Application number: CDN/22/0161

Proposal: Discharge of condition 14 (SUDS1) attached to application ref no 121099

Location: Rammon House , 1 Portugal Street East, Manchester, Manchester, M1 2WX

LLFA Comments 14 April 2022

Typical Green roof Section

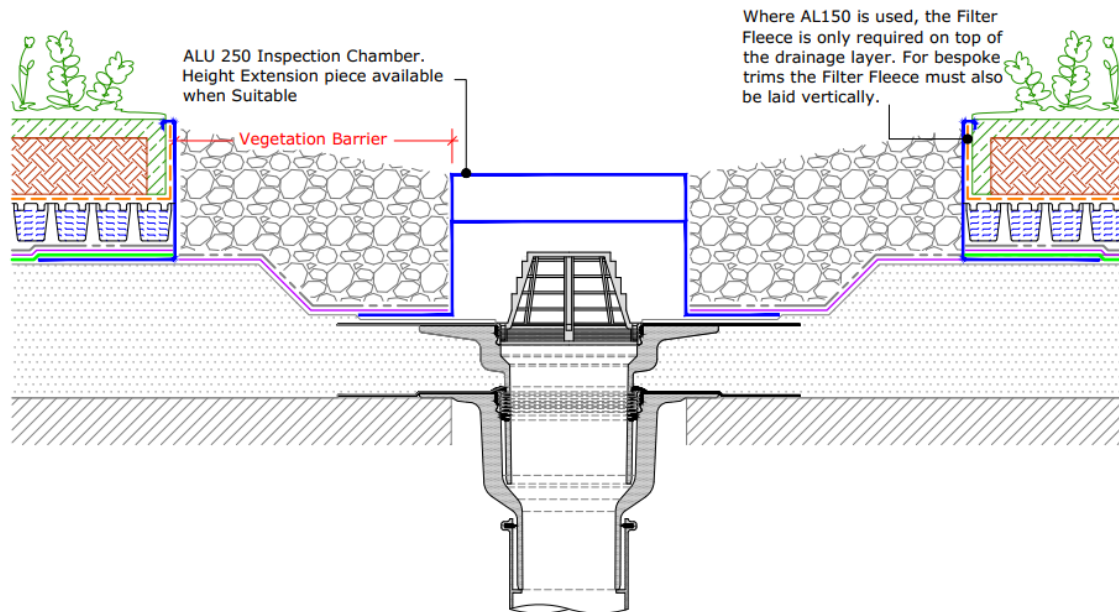
- Please clarify how maximised green SuDS is being provided by this development. Is a green roof being provided, as it is referred to as just a blue roof in submitted drainage layouts, & construction drawing spec is not clear. Please note a blue roof would not be classed as green SuDS. Documents should be updated to show green roof or other green SuDS provisions to be shown. A green roof will be provided to Block 3. A blue roof only will be provided to Block 1 and block 2. Please find attached architectural drawings showing green and blue roof extents with typical details for Block 3. The final blue/green roof will be finalised and designed by a specialist, but the typical construction build up will comprise the following:
